United States Patent and Trademark Office

APPLICATION NO.	FILING DATE	FIRST NAMED INVENTOR	ATTORNEY DOCKET NO.	CONFIRMATION NO.
10/643,406	08/19/2003	Wen Fei Yu	10541-1850	3454
29074 VISTEON	7590 05/24/2007		EXAMINER	
C/O BRINKS	HOFER GILSON & LION	NE	LEO, LEONARD R	
PO BOX 1039 CHICAGO, IL			ART UNIT	PAPER NUMBER
•		•	3744	
•		•		
			MAIL DATE	DELIVERY MODE
			05/24/2007	PAPER

DETAILED ACTION

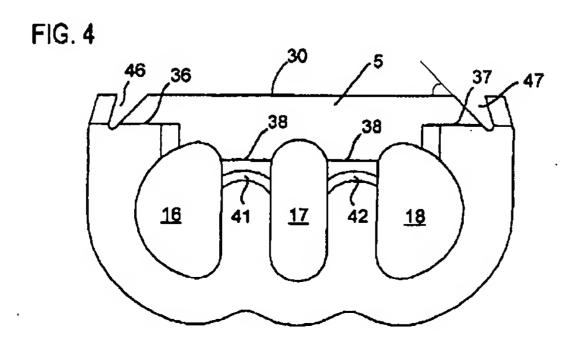
Claims 1-2 and 7-11 are rejected under 35 U.S.C. 102(e) as being anticipated by Petersen. As permissibly gleaned from Figure 4 (below), the unlabelled step portion (near groove 47) extends laterally at an angle of about 45 degrees with the plane of the base portion 30.

Regarding claim 8, Petersen (column 2, line 41) discloses the ends of tube 1 are brazed in slot 5.

Regarding claims 9-11, the juncture between the tube 1 and slot 5 of Petersen inherently meets the claim limitations.
